World Forum for Harmonization of Vehicle Regulations

Working Party on Pollution and Energy

Regulation No. 83(Emissions of M₁ and N₁ categories of vehicles)**Proposal for draft amendments to Supplement 10 to the
05 series of amendments to Regulation No. 83****Submitted by the expert from the Netherlands ***

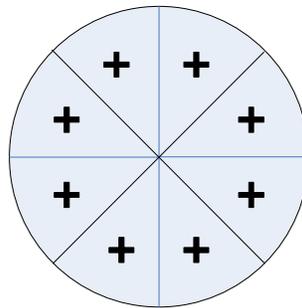
Annex 4, paragraph 6.1.3., amend to read:

- (a) For blowers with rectangular outlets are located at the centre of each rectangle dividing the whole of the blower outlet into 9 areas (dividing both horizontal and vertical sides of the blower outlet into 3 equal parts). **The centre area shall not be measured (as shown in the diagram below).**

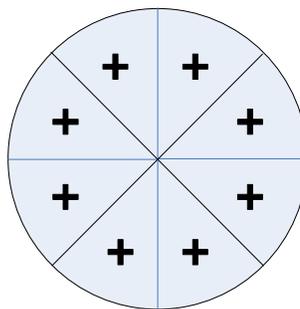
Annex 4a, paragraph 3.4.2., amend to read:

- (a) For blowers with rectangular outlets are located at the centre of each rectangle dividing the whole of the blower outlet into 9 areas (dividing both horizontal and vertical sides of the blower outlet into 3 equal parts). **The centre area shall not be measured (as shown in the diagram below).**
